**STAFF RECOMMENDATION**  
**2125 Belmont Boulevard**  
**July 20, 2016**

**Application:** New construction-Addition, Detached accessory dwelling unit (DADU),  
Setback determination

**Description of Project:** Application for a rear addition to the house, and a detached accessory dwelling unit (DADU). The DADU requires a setback determination from twenty feet (20') to ten feet (10').

1ST, 2ND FLR PLNS

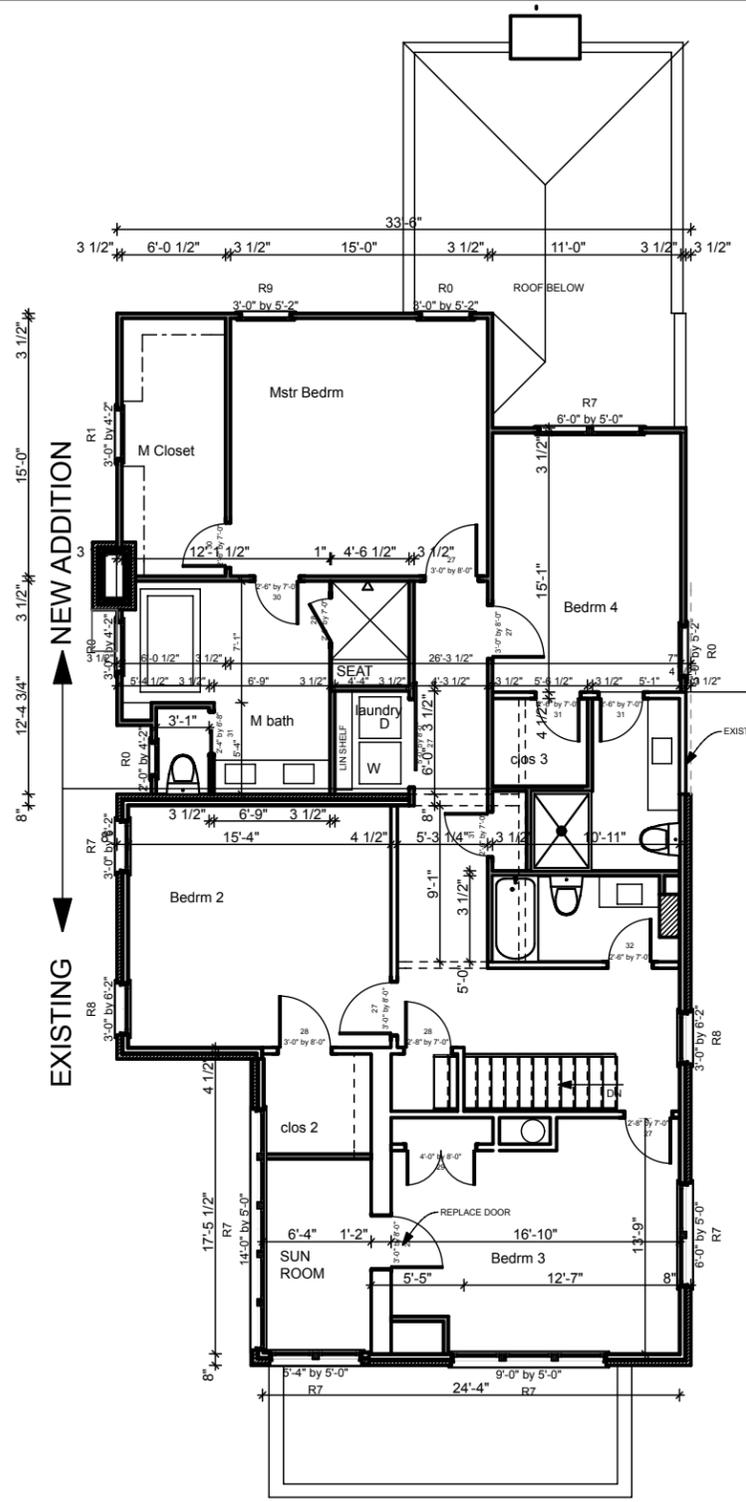
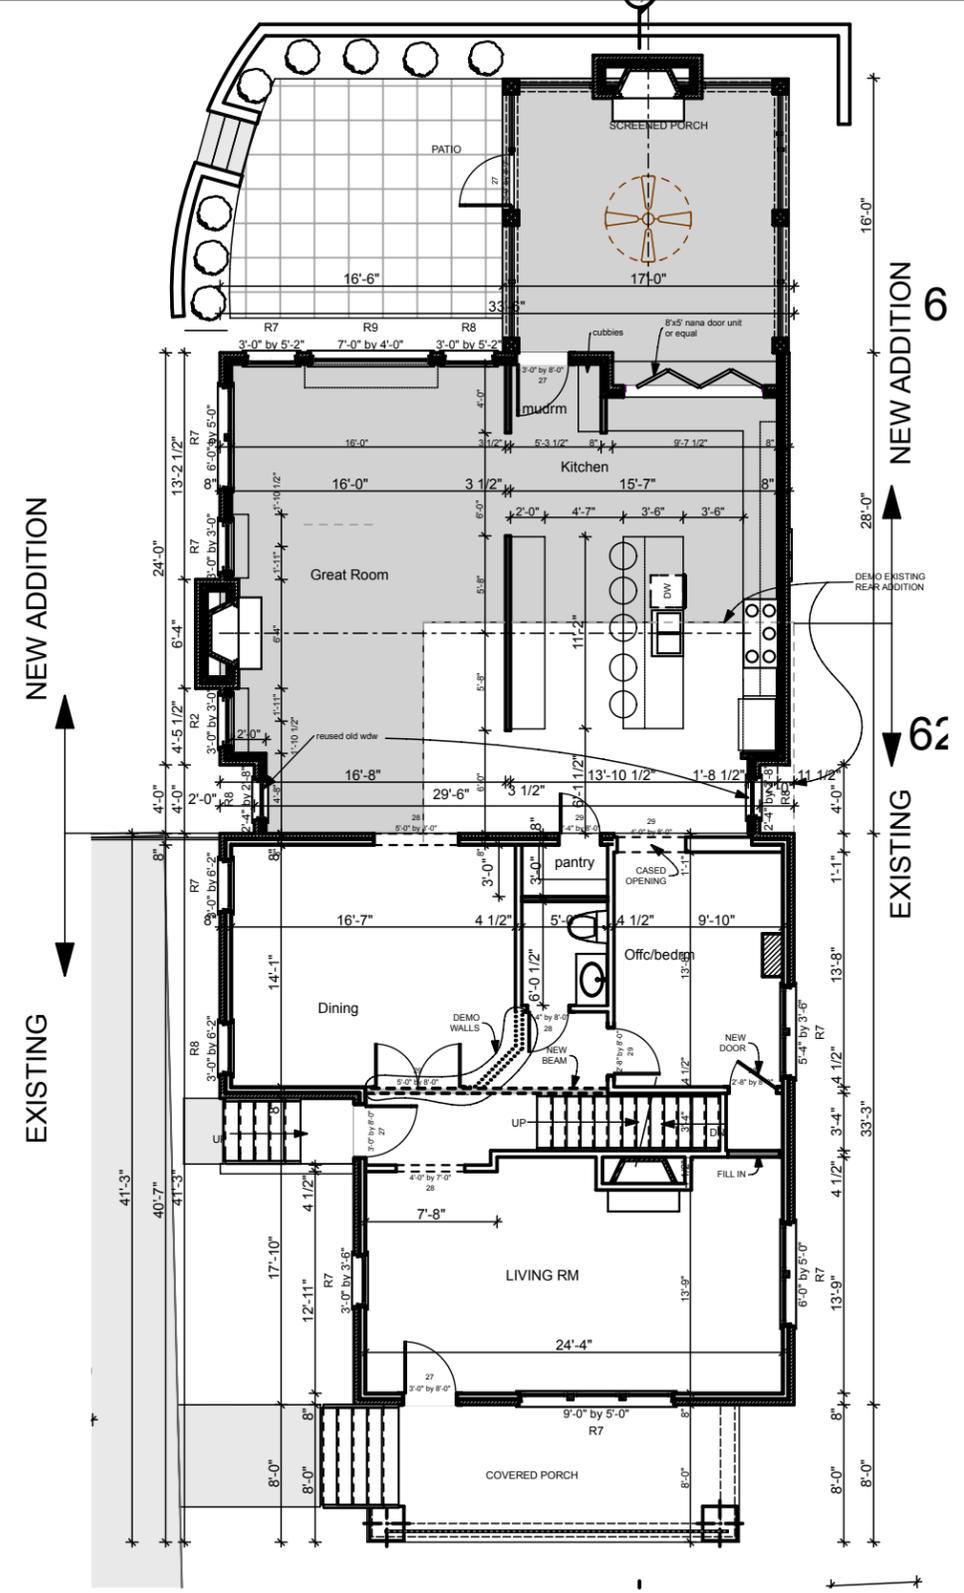
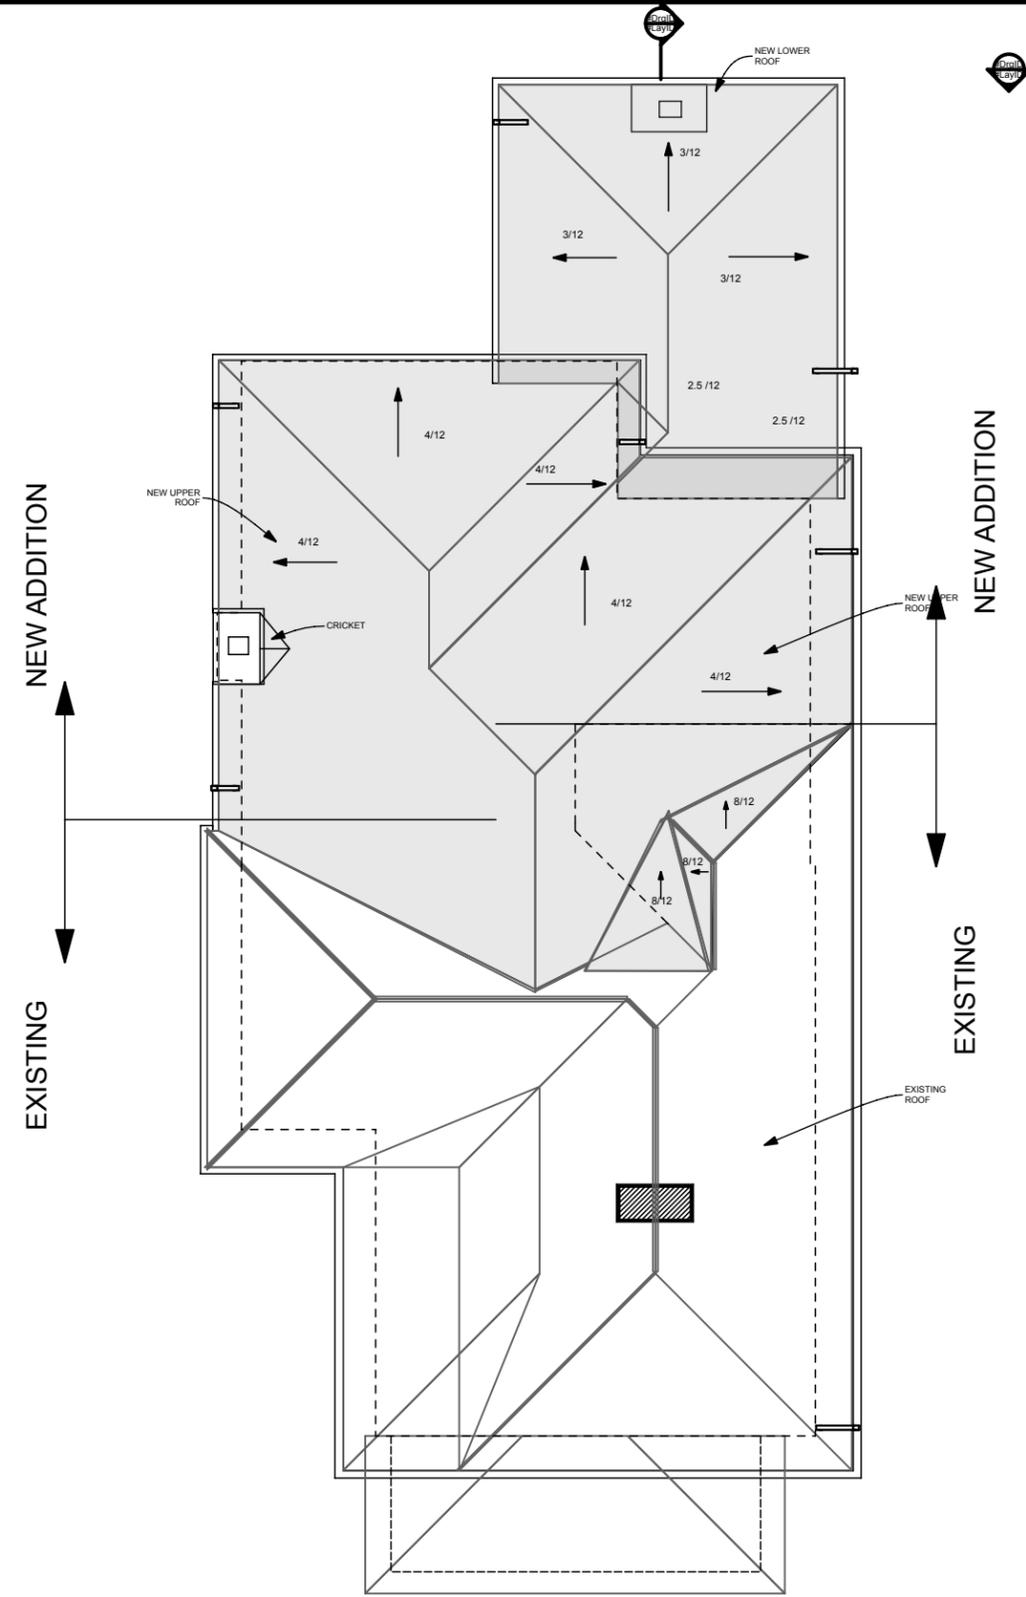
**Height & Scale:** The addition will set in two feet (2') on each side, and after four feet (4') will expand on each side to match the width of the house. On the left side of the addition, a chimney projects out one foot (1') to that side. As this is only six feet, four inches (6' 4") of overall depth, and is in a minimally-visible location toward the rear of the house, staff finds this to be appropriate. The foundation height of the addition will match the house's foundation height. The eave height of the addition will match that of the house, approximately seventeen feet (17') above the floor level. The addition's overall height is two feet (2') below the ridge of the house. The project meets section II.B.1.a and b.

**Location & Removability:** The addition will be at the rear of the house, where there is an existing rear porch. The rear corners of the house will remain. If the addition were to be removed in the future, the original form of the house would remain. The location is appropriate and the project meets section II.B.2.a and e.

**Design:** The addition's design complements the historic structure with a brick first story. It is differentiated with insets and different material on the second story. The project meets section II.B.2.a and f.

**Setback & Rhythm of Spacing:** The addition will be eleven feet (11') from the left side property line, and six feet (6') from the right side. The rear setback is fifty feet (50'). The addition's setbacks meets base zoning requirements and the project meets section II.B.1.c and II.B.2.

ELEVATIONS

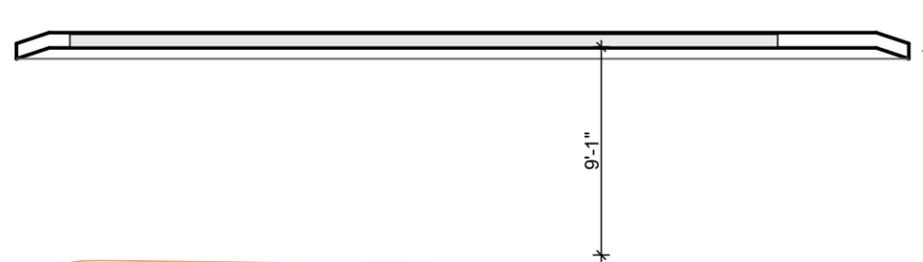
Roof form: The addition has a hipped roof form with 4/12 pitch. The screened porch at the rear is also hipped, with 3/12 pitch. The project meets section II.B.1.e.

Proportion and Rhythm of Openings: The windows on the proposed addition are all generally twice as tall as they are wide, meeting the historic proportions of openings. The largest expanse of wall space without a window or door opening is ten feet (10') on the right side at the rear of the addition, which is a minimally-visible location. Staff finds the project's proportion and rhythm of openings to meet Section II.B.1.g.

DADU/CARPORT

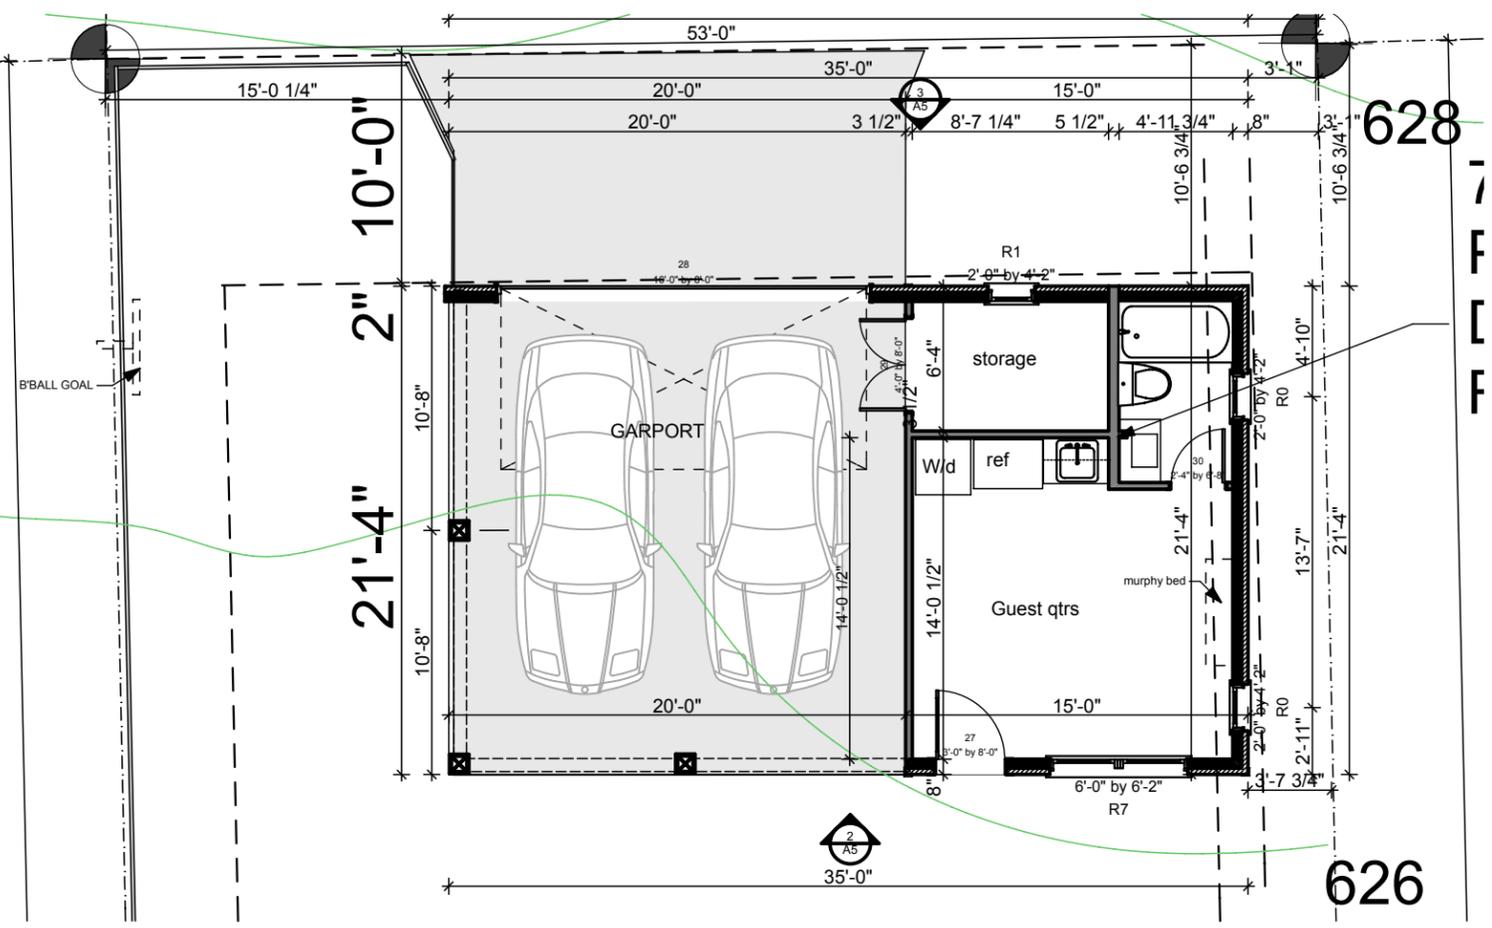
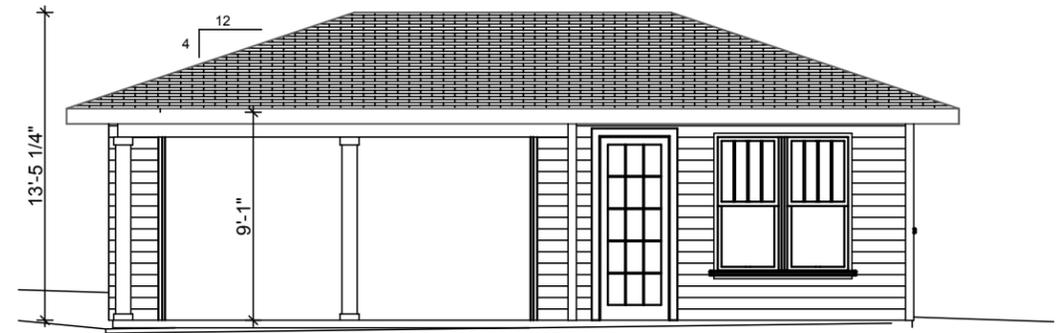
The applicant proposes construction of a new one-story garage and detached accessory dwelling unit (DADU) at the rear of the lot.

Since the form and slopes are similar to historic outbuildings, the project meets Section II.B.8 of the design guidelines and section 17.16.030.G.8 of the ordinance.

The accessory structure has a simple, utilitarian design that is appropriate for outbuildings. Its roof form, detailing, and form do not contrast greatly with the primary structure. It is also in a minimally-visible location at the rear of the lot.

With the staff’s final approval of the siding, roofing color, windows and doors, and materials that have not yet been provided, staff finds that the application meets Section II.B.8

The new outbuilding requires a rear setback determination from twenty feet (20') to seven feet, six inches (7' 6"). In one place you said that the rear setback request was 10' (I've deleted) and here it is 7'—which is it? A reduced rear setback is appropriate for outbuildings historically, and has been approved by the Commission recently and because outbuildings were typically located close to rear property lines. The project meets section II.B.8 and section 17.16.030.G of the ordinance.

1. Staff approve windows, and doors prior to purchase and installation;
2. Staff approve the roof color and masonry color, dimensions and texture;
3. Staff approve any unspecified materials for the outbuilding;
4. The restrictive covenant is filed, acknowledging the requirements of section 17.16.030.G of Metro Code.
